# SPRINGS AT WATERVIEW PRELIMINARY PLAN

LOCATED IN THE NW 1/4 OF SECTION 7, T15S, R65W OF THE 6TH P.M.,  
EL PASO COUNTY, STATE OF COLORADO

SHEET TITLE TITLE SHEET

REVISIONS:		
NO.	DESCRIPTION	DATE
1	CITY REVIEW COMMENTS	1/5/18

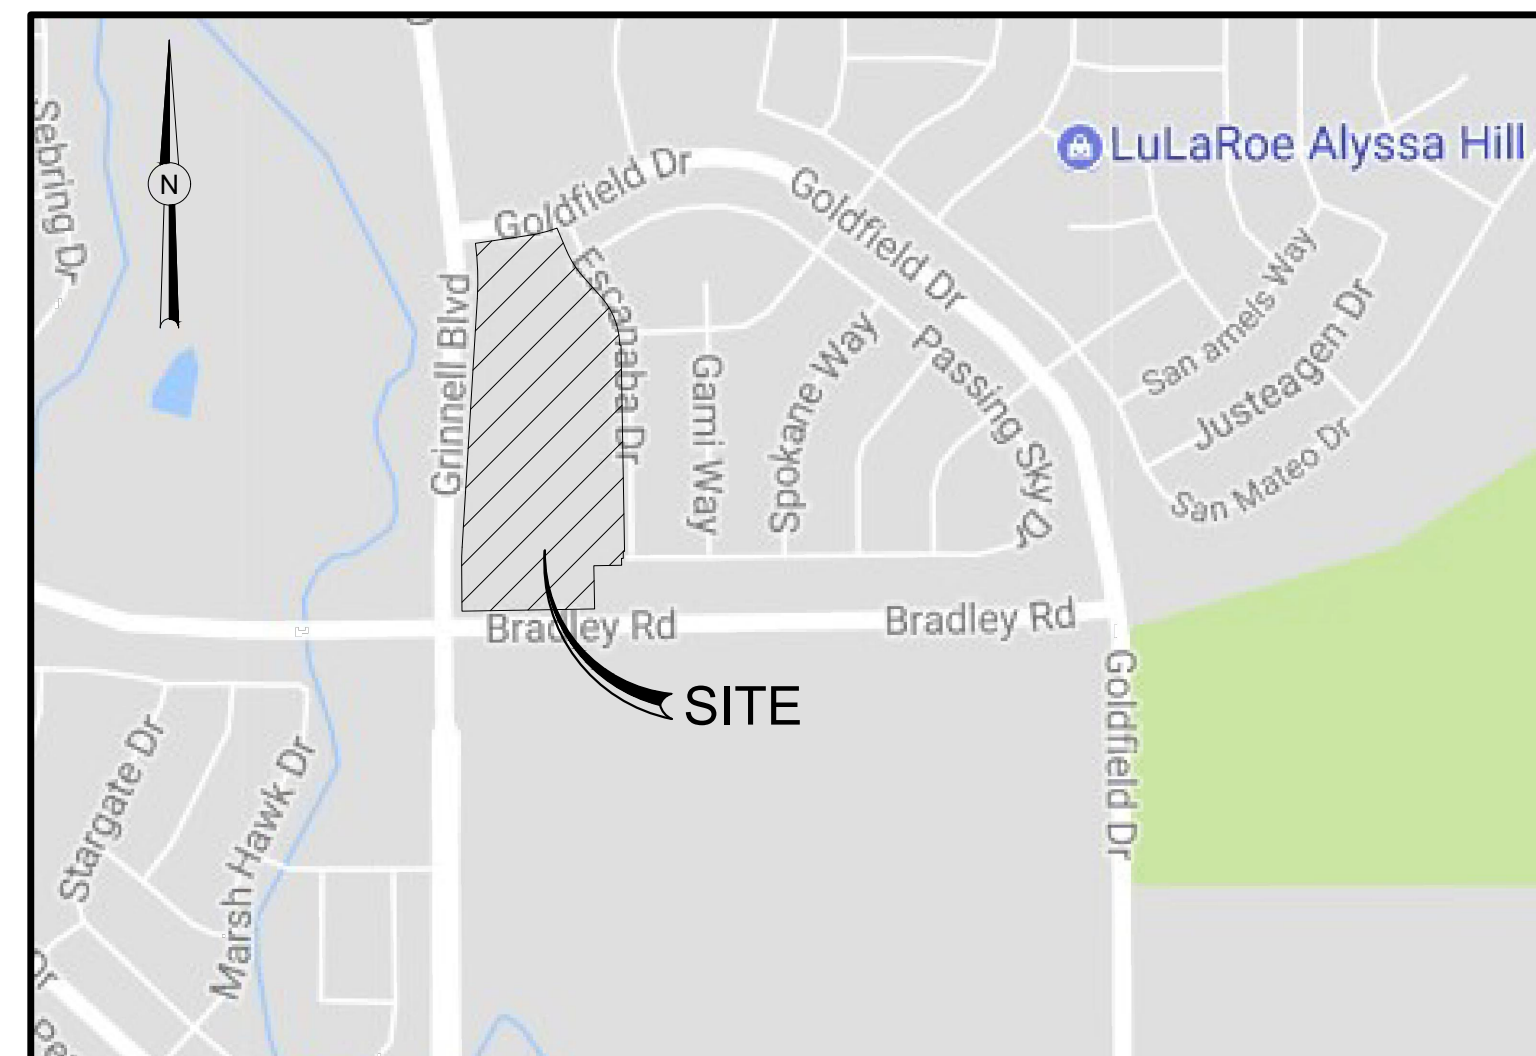
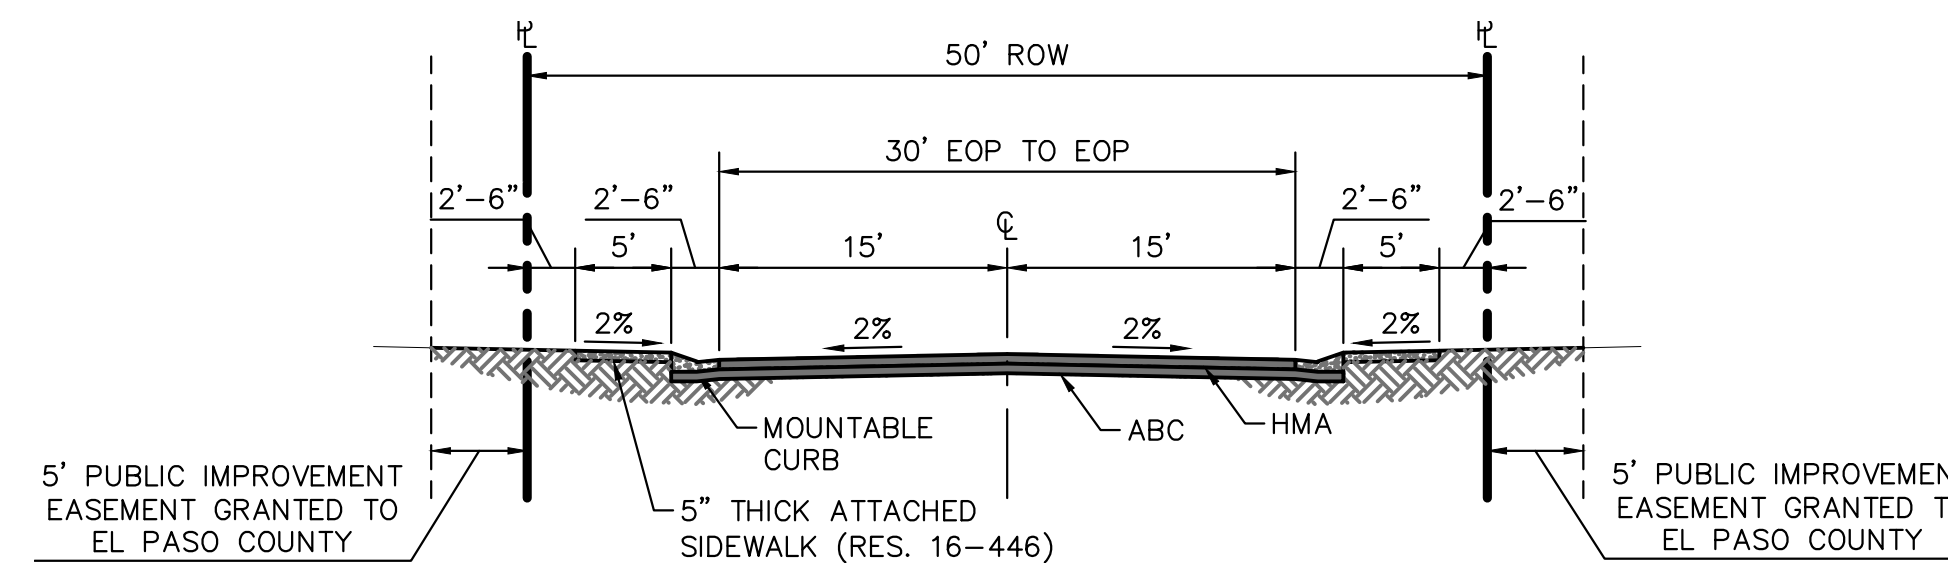
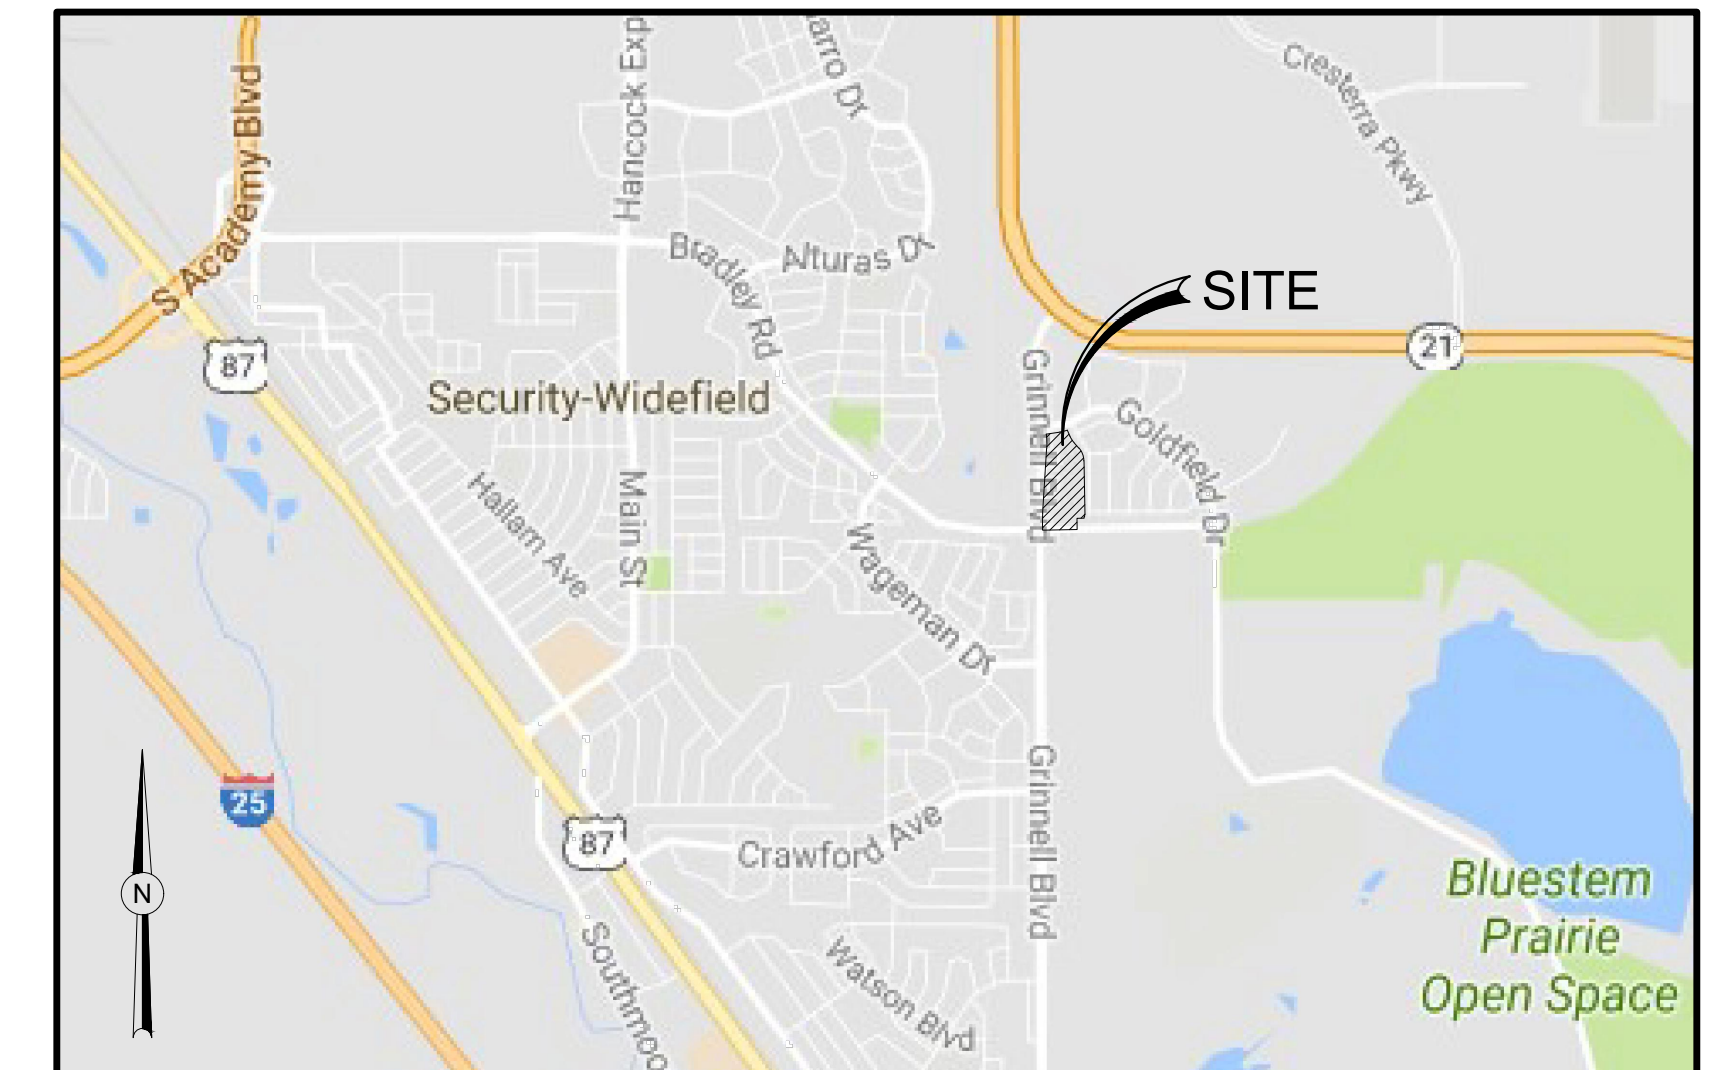
- NO PART OF THIS PROPERTY FALLS IN THE 500 YEAR FLOOD PLAIN (EST. BY FEMA). Provide the specific FEMA FIRM Panel No. Unresolved.
- NOTWITHSTANDING ANYTHING DEPICTED IN THESE PLANS IN WORDS OR GRAPHIC REPRESENTATION, ALL DESIGN AND CONSTRUCTION RELATED TO ROADS, STORM DRAINAGE AND EROSION CONTROL SHALL CONFORM TO THE STANDARDS AND REQUIREMENTS OF THE MOST RECENT VERSION OF THE RELEVANT ADOPTED EL PASO COUNTY STANDARDS, INCLUDING THE LAND DEVELOPMENT CODE, THE ENGINEERING CRITERIA MANUAL, THE DRAINAGE CRITERIA MANUAL, AND THE DRAINAGE CRITERIA MANUAL VOLUME 2. ANY DEVIATIONS FROM REGULATIONS AND STANDARDS MUST BE REQUESTED AND APPROVED IN WRITING TO BE ACCEPTABLE.

- THERE WILL BE NO DIRECT LOT ACCESS TO BRADLEY ROAD, ESCANABA DRIVE, GOLDFIELD DRIVE, AND ESCANABA BLVD. FROM ANY LOT OR TRACT. VEHICULAR ACCESS TO LOTS ABUTTING TRACT A IS NOT PERMITTED. Duplicate

- ALL SIGHT TRIANGLES WILL BE CREATED BY ROW DEDICATION. Add Grinnell Blvd.
- THIS DEVELOPMENT WILL PARTICIPATE EQUITABLY IN THE CONSTRUCTION OF A TRAFFIC SIGNAL AT GOLDFIELD DRIVE AND GRINNELL BOULEVARD.

This seems out of place
